Access Compliance Report Public Rights-of-Way (Curb Ramps)

Main Street: ANTONIO_PKWY Cross Street: WINDMILL_AVE Location: E

ADA ID: RPRK211029142026 Ramp Type: Type 1 - Perpendicular Diagonal Initial Pass/Fail: Pass Overall Compliance: No Severity Score: 10

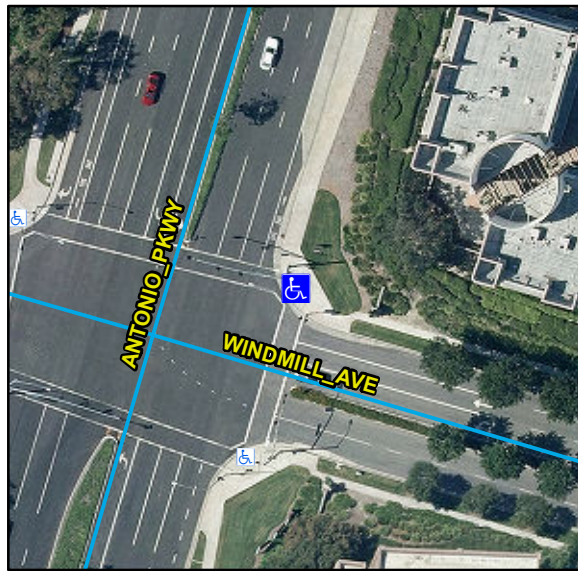
Compliance	Description	Data	Compliance	Description	Data
N/A	Ramp Length (in)	79	N/A	Flare Type LT	
Yes	Ramp Width (in)	48			Sloped
Yes	Ramp Run Slope (%)	4.9	Yes	Flare Slope LT (%)	8.4
Yes	Ramp Cross Slope (%)	0.9	N/A	Flare Traversable LT	Yes
N/A	Landing Present	Yes	N/A	Flare Type RT	
N/A	Landing Length (in)	50			Sloped
Yes	Landing Width (in)	48	Yes	Flare Slope RT (%)	6.3
No	Landing Run Slope (%)	2.3	N/A	Flare Traversable RT	Yes
Yes	Landing Cross Slope (%)	1.3	No	DWS Provided	No
N/A	Landing Movement Obstructed?	No	N/A	DWS Contrast	N/A
	Landing Movement Type	N/A	N/A	DWS Length (in)	N/A
N/A	Landing Shared	No	N/A	DWS Full Width	N/A
Yes	Clear Space	Yes	N/A	DWS Offset Left (in)	N/A
Yes	Clear Space To Crosswalk (in)	48	N/A	DWS Offset Right (in)	N/A
N/A	Marked Crosswalk 1	Yes	N/A	Marked Crosswalk 2	Yes
	Crossing 1 Direction	NW		Crossing 2 Direction	SW
	Marked Crosswalk 1 Width (in)	110		Marked Crosswalk 2 Width (in)	110

Yes	Ramp Inside Crosswalk 1	Yes	Yes	Ramp Inside Crosswalk 2	Yes
	Crossing 1 Slope (%)	1.6		Crossing 2 Slope (%)	0.6
	Crossing 1 Cross Slope (%)	2.1		Crossing 2 Cross Slope (%)	1.2
Yes	Gutter Ponding	No	No	Curb Slope	8.6
Yes	Gutter Lip Height (in)	0		Road Run Slope (%)	1.3
Yes	Gutter Run Slope (%)	1.4		Road Cross Slope (%)	1.6
Yes	Gutter Cross Slope (%)	0.9			
Yes	Overall Surface Condition: Acceptable		Yes	Perp Joint Present	Yes
	Cross Gutter Present?	No		Spandrel Present?	No
	Replace Cross Gutter?	N/A		Replace Spandrel?	N/A

Remove & Replace Curb Ramp With Two New Directional Ramps or Equivalent.
